ND-2013-0002  
January 11, 2013

Subject: **PSEG Early Site Permit Application**  
**Docket No. 52-043**  
**Response to Request for Additional Information, RAI No. 61, Vibratory**  
**Ground Motion**

Enclosure 1: Response to NRC Request for Additional Information, RAI No. 61,  
Question No. 02.05.02-10, SRP Section: 02.05.02 – Vibratory Ground  
Motion

**Response to RAI No. 61**

**Table RAI-61-10-14**

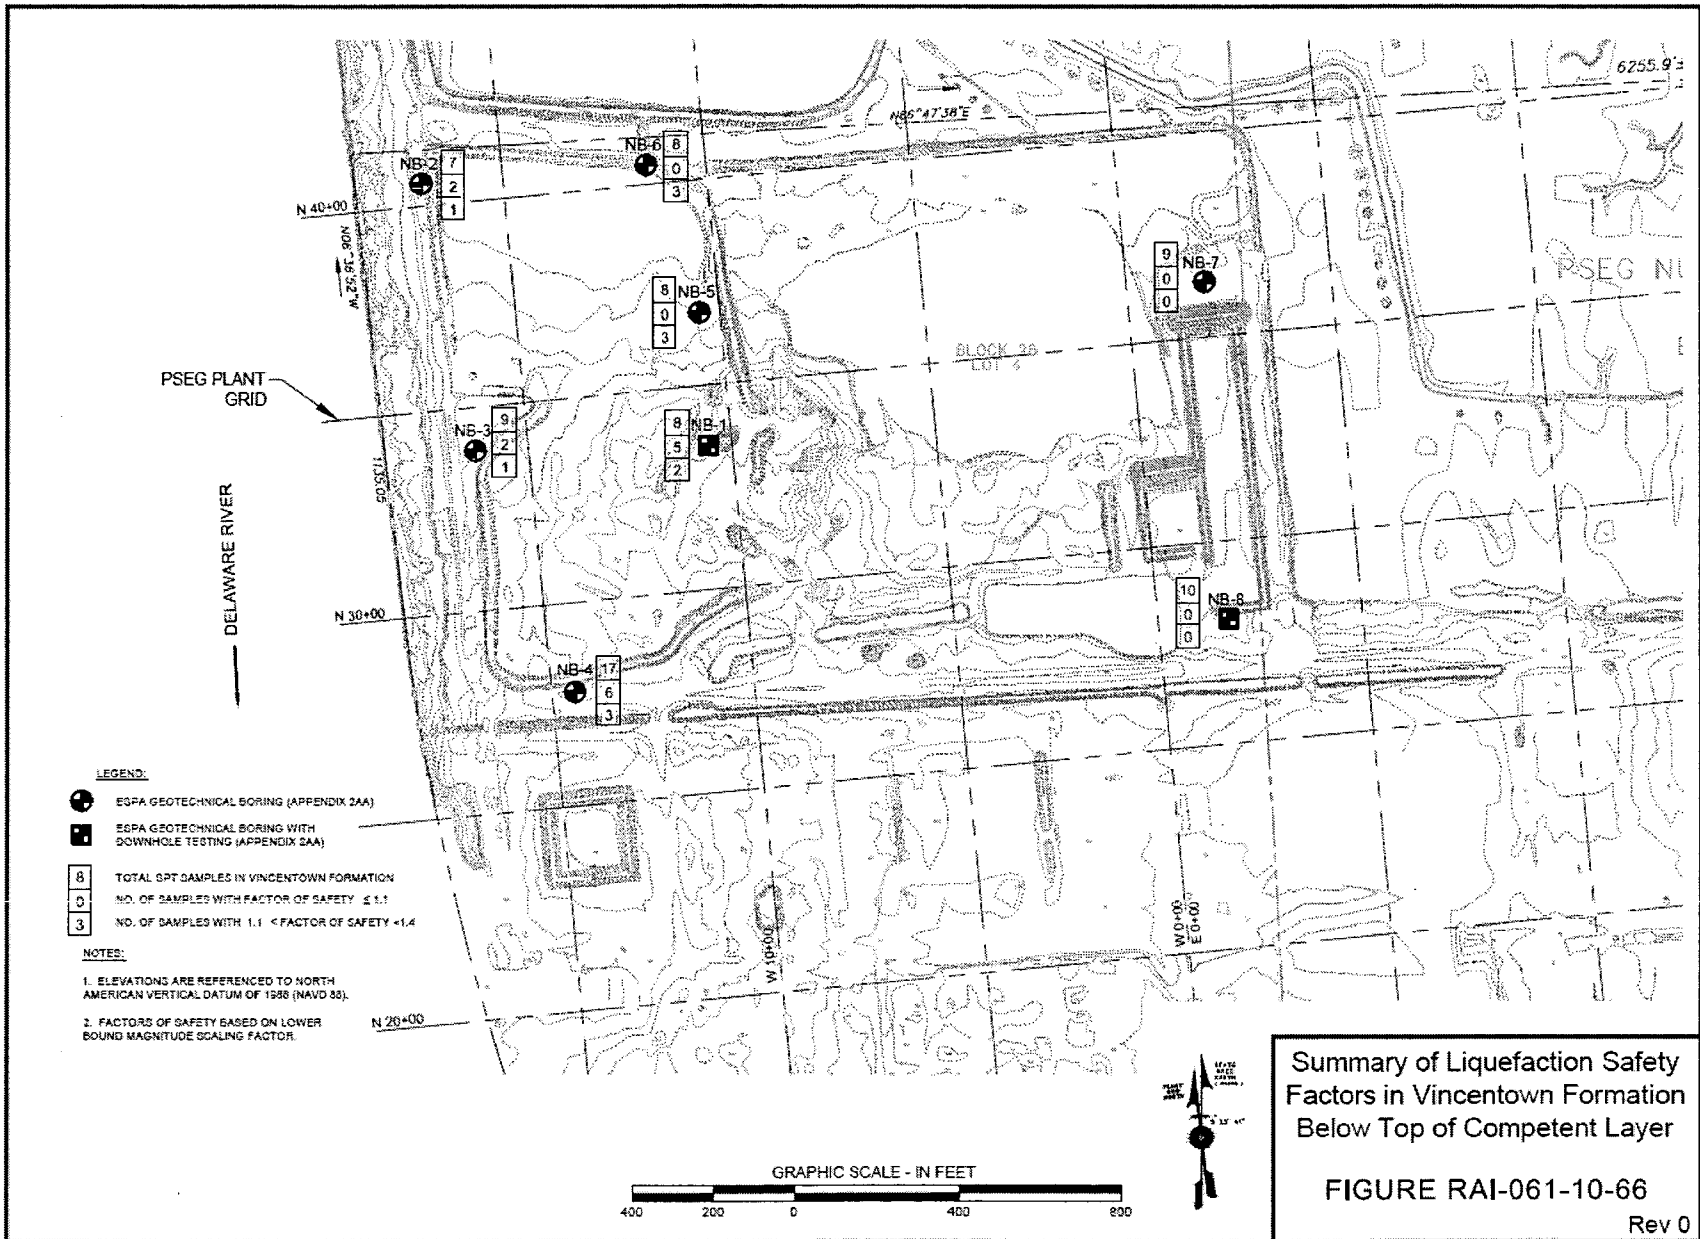
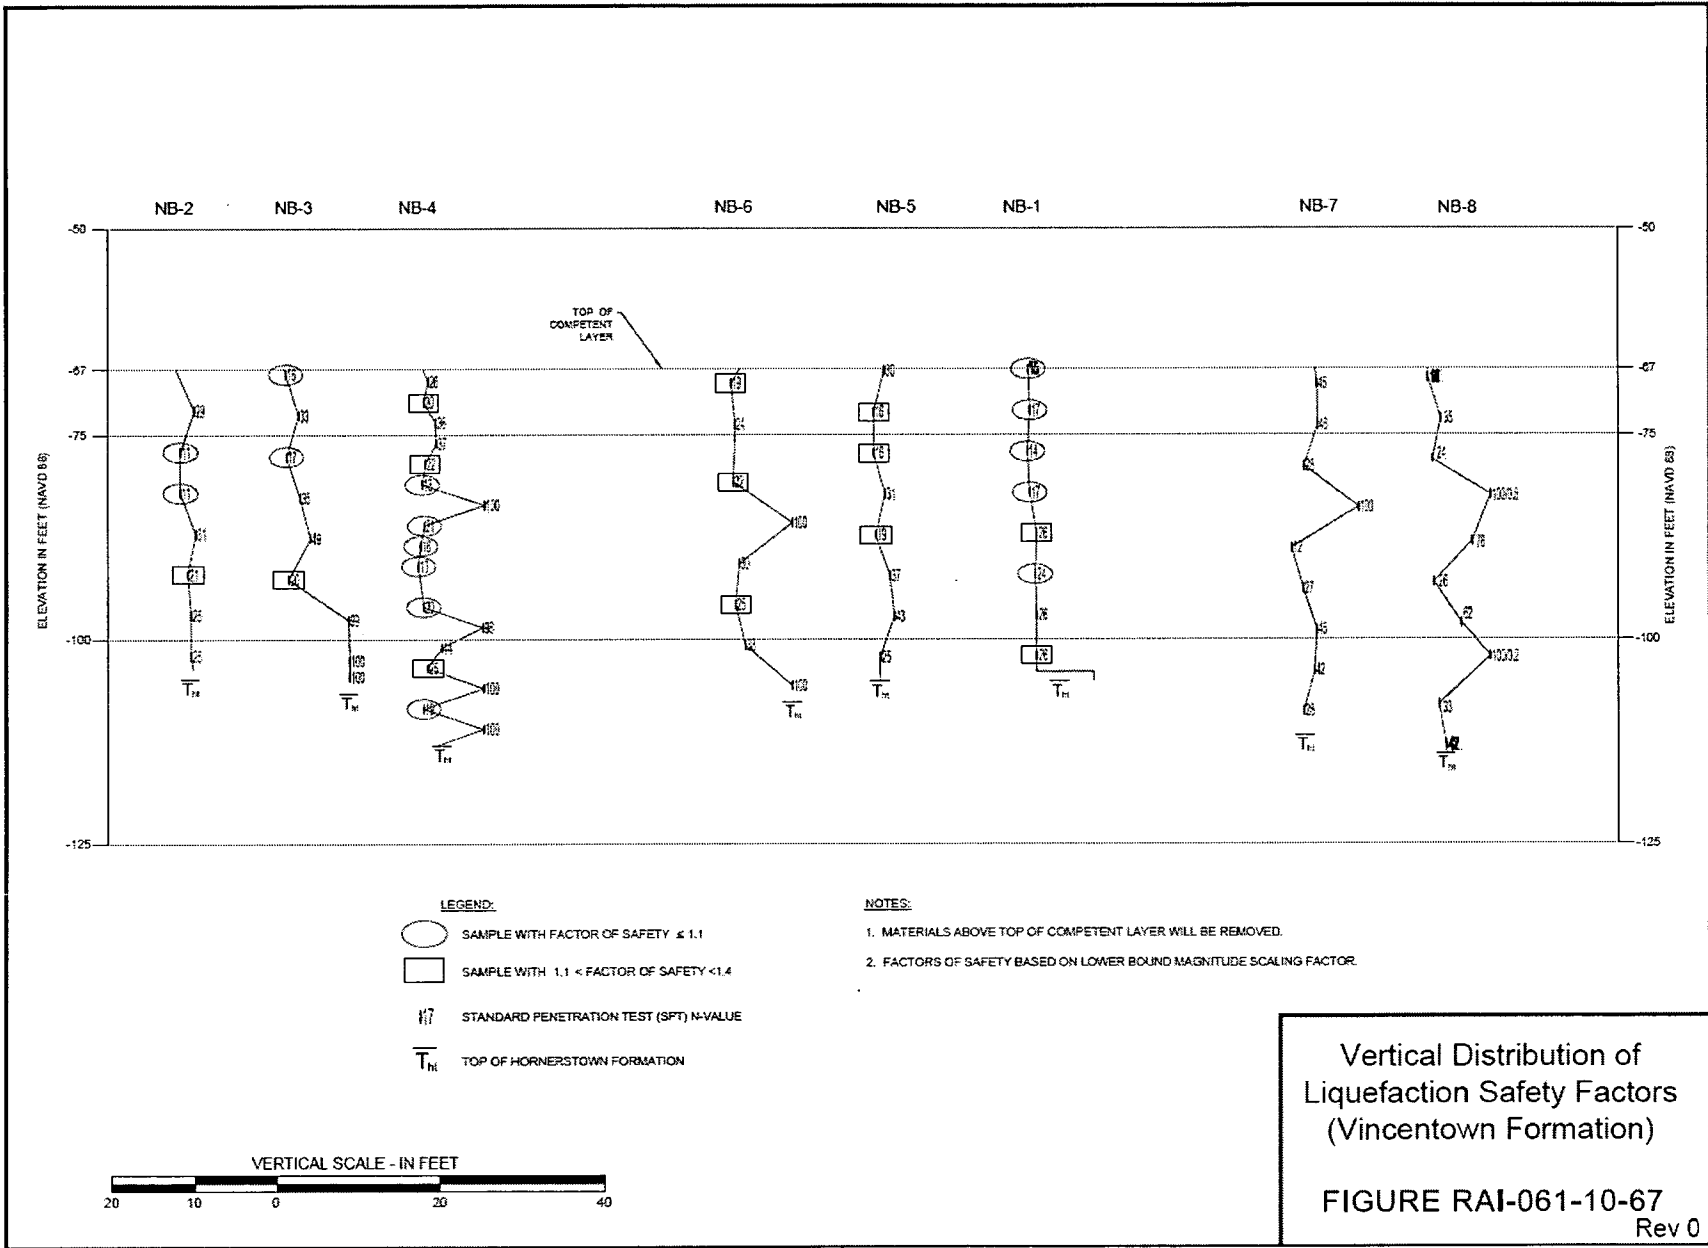
*a) Evaluate the potential impacts of the newly released CEUS-SSC model, with potential local and regional refinements as identified in the CEUS-SSC model, on the seismic hazard curves and the site-specific ground motion response spectra (GMRS). For re-calculation of the PSHA, please follow either the cumulative absolute velocity (CAV) filter or minimum magnitude specifications outlined in Attachment 1 to Seismic Enclosure 1 of the March 12, 2012, letter "Request for information pursuant to title 10 of the Code of Federal Regulations 50.54(f) regarding recommendations 2.1, 2.3, and 9.3, of the near-term task force review of insights from the Fukushima Dai-ichi accident." (ML12053A340)*

*b) Modify the site-specific GMRS if you determine changes are necessary given the evaluation performed in part a) above.*

Reference 6, the value of GMRS at 100 Hz using the CEUS-SSC (NUREG-2115) is 0.225g, which is greater than the value presented in existing Subsection 2.5.4.8.3 (0.18g). Calculation 360-RAI-061-10 examines the effect of the higher input acceleration on the calculated factors of safety against liquefaction (Reference RAI-61-10-13).

The results of the calculation, summarized in Table RAI-61-10-14, show an increase in the numbers of samples with factors of safety less than or equal to 1.1 from 3 to 17, and an increase in the numbers of samples with factors of safety greater than 1.1 but less than 1.4 from 9 to 15. The total number of samples reviewed is 257. Distribution of the samples with low factors of safety within the Vincentown Formation, the formation at and below the level of the competent layer, is illustrated on Figures RAI-61-10-66 and RAI-61-10-67. The SPT-based screening calculation results indicate the potentially liquefiable soils in the Vincentown Formation are isolated zones surrounded by denser materials, not a continuous layer.
